Access Compliance Report

Public Rights-of-Way

Intersection ID: 20860	Main Street: CROWNPOINT_EXECUTIVE_DR	Cross Street: KREFELD_DR	Location: SW
ADA ID: A7B6F8EDFC60	Ramp Type: PerpDiag	Initial Pass/Fail: Fail	Overall Compliance: No
Severity Score: 8.75			
Codes/Mitigation Info/Possible Solution		Field Measurements/Component Compliance

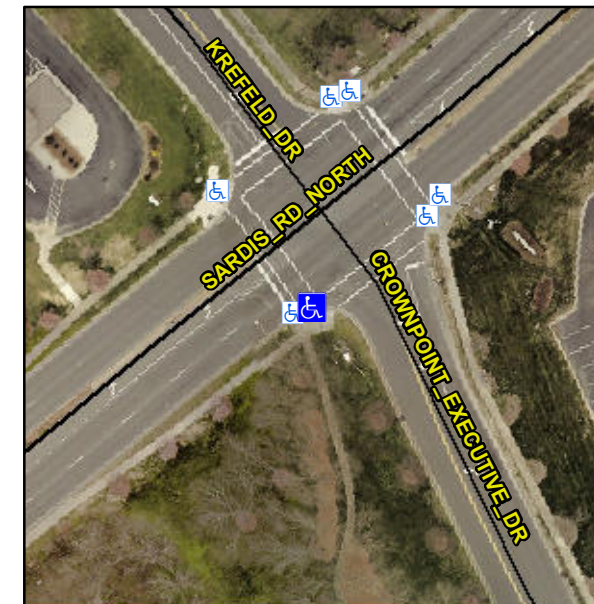
Not Found, R304.5.1

Compliance	Description	Data	Compliance	Description	Data
N/A	Ramp Length (in)	64.0	Yes	Ramp Slope (%)	8.3
No	Ramp Width (in)	42.0	Yes	Ramp XSlope (%)	0.6
N/A	Flare Type LT	N/A	N/A	Flare Type RT	N/A
N/A	Flare Slope LT (%)	N/A	N/A	Flare Slope RT (%)	N/A
N/A	Flare Traversable LT?	N/A	N/A	Flare Traversable RT?	N/A
N/A	Landing Length (in)	N/A	N/A	DWS Provided?	N/A
N/A	Landing Width (in)	N/A	N/A	DWS Contrast?	N/A
N/A	Landing Slope (%)	N/A	N/A	DWS Length (in)	N/A
N/A	Landing X Slope (%)	N/A	N/A	DWS Full Width?	N/A
N/A	Landing Curb? (Y/N)	N/A	N/A	DWS Offset (in)	N/A
N/A	Shared Landing?	N/A			
N/A	Gutter Ponding?	N/A	N/A	Gutter Slope (%)	N/A
N/A	Gutter Lip Ht (in)	N/A	N/A	Gutter X Slope (%)	N/A
N/A	Painted X Walk1?	Yes	N/A	Painted X Walk2?	Yes
	X Walk 1 Direction	To NE		X Walk 2 Direction	To NW
N/A	X Walk 1 Width (in)	105.0	N/A	X Walk 2 Width (in)	117.0
	X Walk 1 Slope (%)	4.4		X Walk 2 Slope (%)	0.0
	X Walk 1 X Slope (%)	3.7		X Walk 2 X Slope (%)	2.4

N/A	Ramp inside XWalk1?	Yes	N/A	Ramp inside XWalk2?	Yes
	Road Slope (%)	0.3	N/A	Clear Space?	N/A
	Road X Slope (%)	6.6	N/A	Clear Space to XWalk (in)	N/A
N/A	Any Obstructions?	N/A	N/A	Storm Grate/Utility Hazard?	N/A
	Obstruction Type			Storm Grate/Utility Type	
		N/A			N/A
		Yes		Surface Condition? (G/P)	Good

Remove & Replace Curb Ramp With Two New Directional Ramps or Equivalent.
